N9915A-02

S E R V I C E N O T E

N9915A FieldFox Handheld Analyzer

Figure 1: Image showing the good and bad inductor on location U678 at RF Board

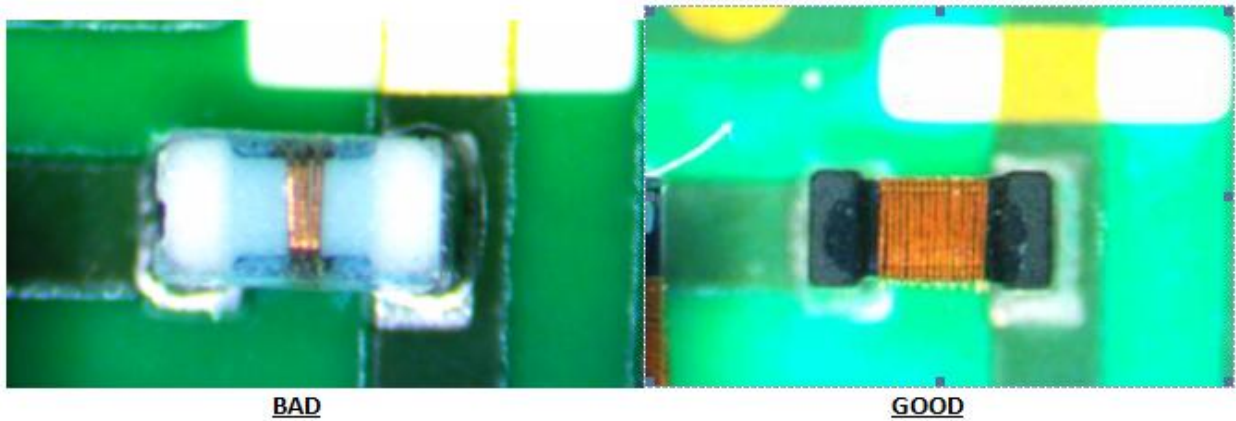
FieldFox instruments with the serial numbers listed below may show potential DANL failures with 3-4 dB difference due to misloaded inductor on the RF board. If DANL improvement is necessary, a new RF board is available to fix this it.

Affected FieldFox with necessary DANL improvement are required to send back to Agilent factory for a new RF board replacement. Test and Adjustment shall be done before shipping back to customer.
